SERVICE No. 1026 BULLETIN

SUBJECT:

of dry air pump flexible couplings".

Distribution of Parker Hannifin Airborne Service Letter 48, "Inspection/Replacement

FIGURE 1

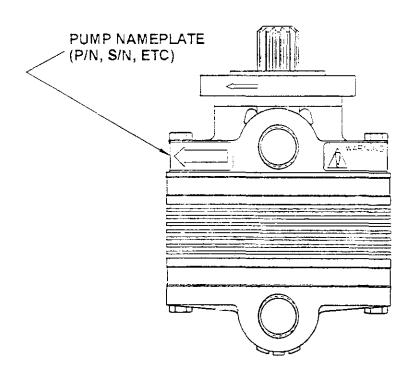
Refer to Figure 1 for location of part number/serial number nameplate.

FIGURE 2

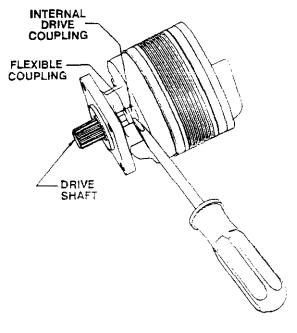
- 1) Remove dry air pump from engine accessory pad per instructions provided by the airframe manufacturer in the appropriate maintenance publication.
- 2) Insert a screwdriver or similar tool between the flexible coupling assembly (2-piece and the pump's internal drive coupling. Remove the flexible coupling assembly from pump, taking care not to damage any of the eight drive pins. Refer to Figure 2.
